Service Letter No. 410

**SUBJECT:** Inspection and Lubrication of Stabilizer Yoke and Yoke Screw

**MODELS AFFECTED:** All PA-22 Series Aircraft

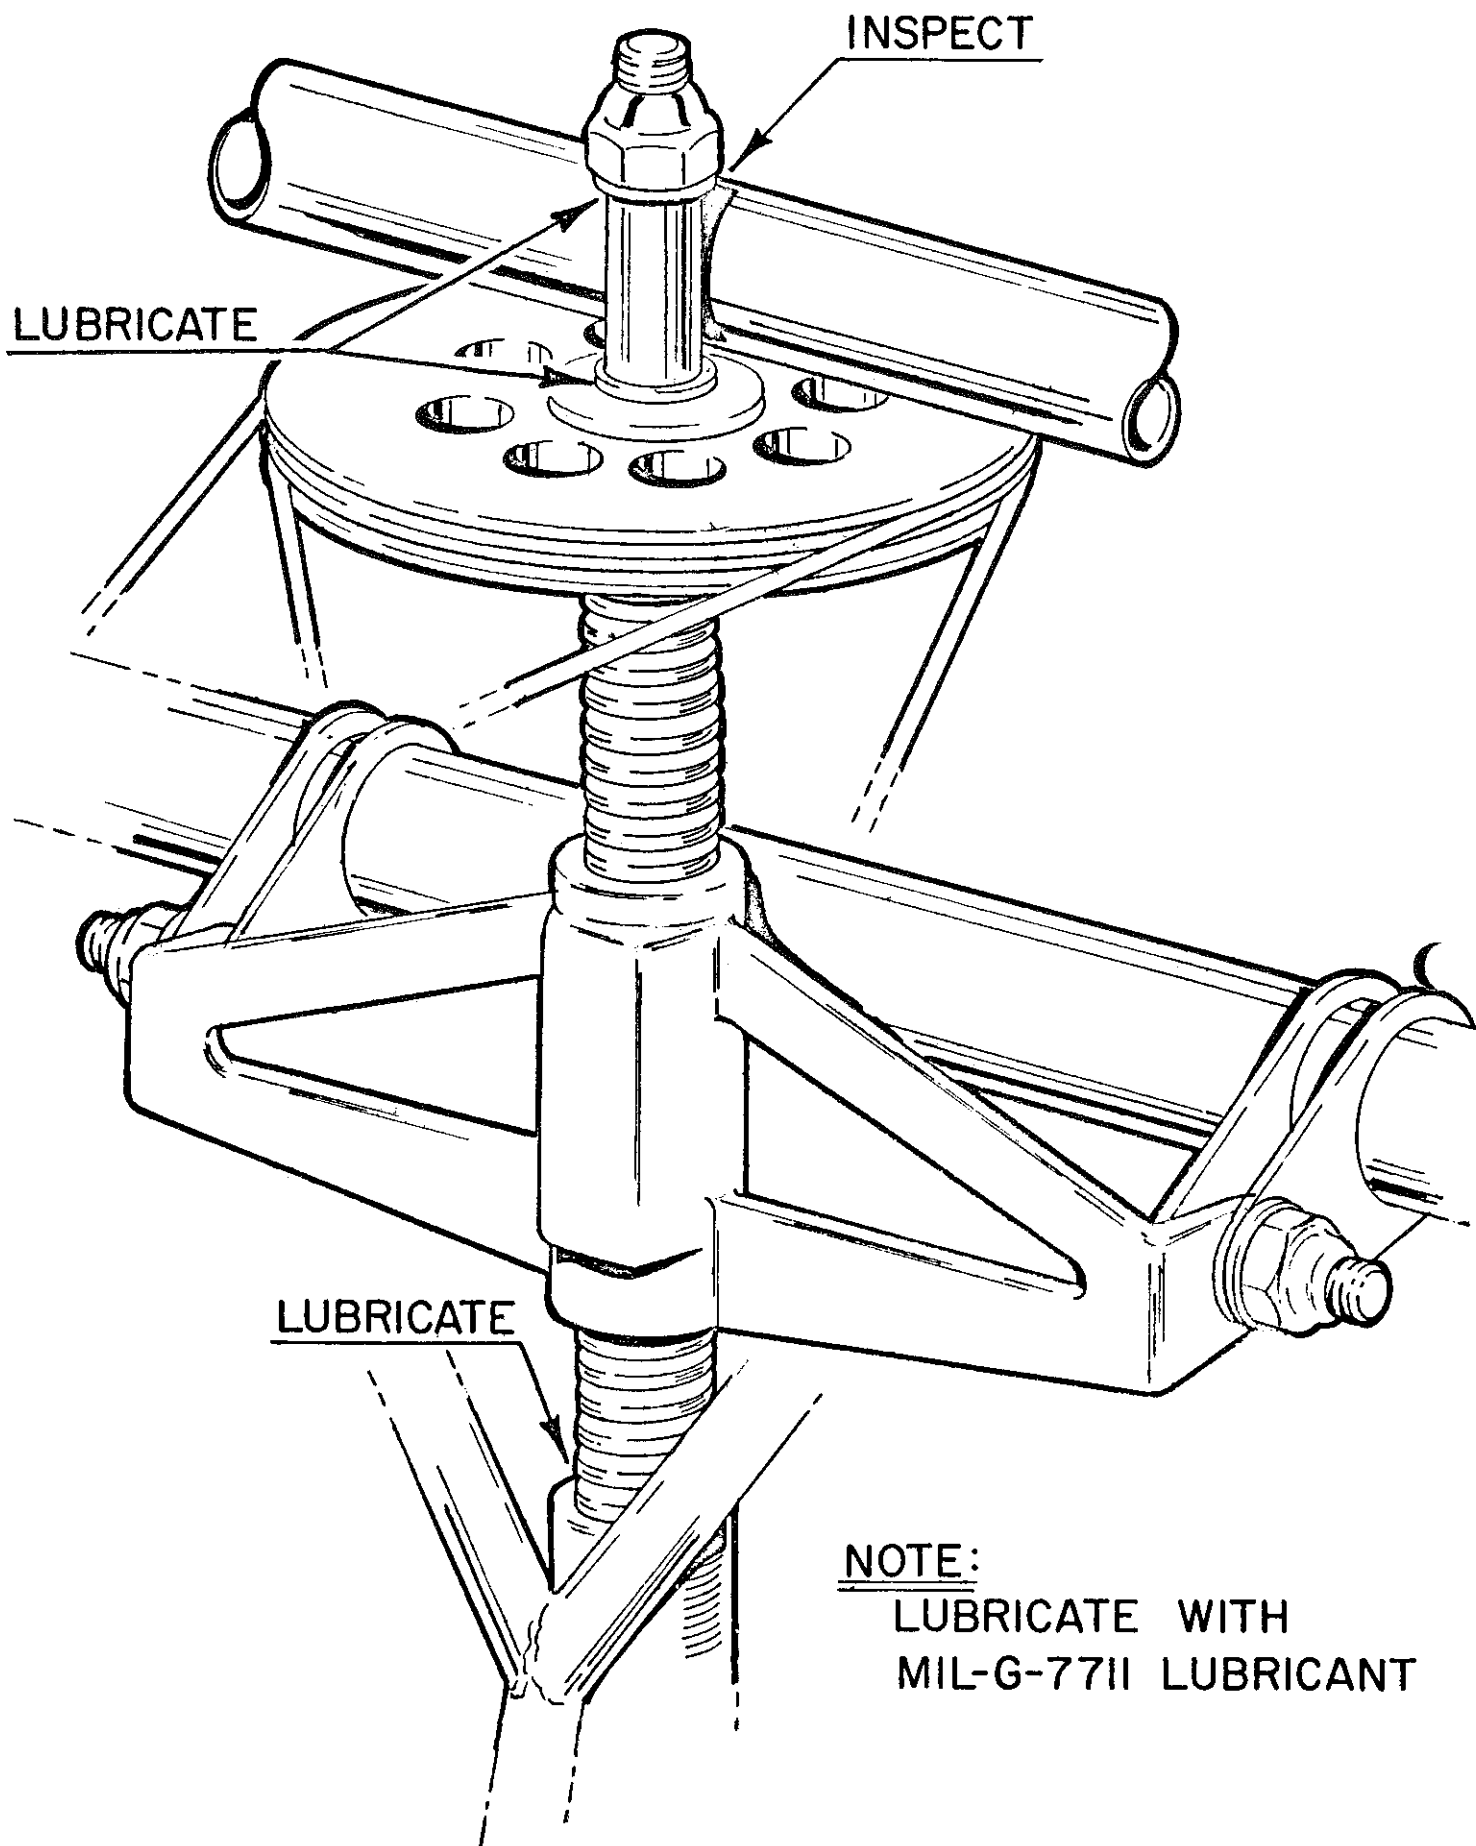
This Service Letter is to advise owners and operators of the subject aircraft that at each 100 hour inspection, the bushing, washer and nut of the stabilizer yoke assembly should be inspected for wear and, if worn, should be replaced.

At this time, the bushing and surfaces of the washer should be lubricated.

See sketch on the reverse side of this Service Letter for details of inspection and lubrication requirements.
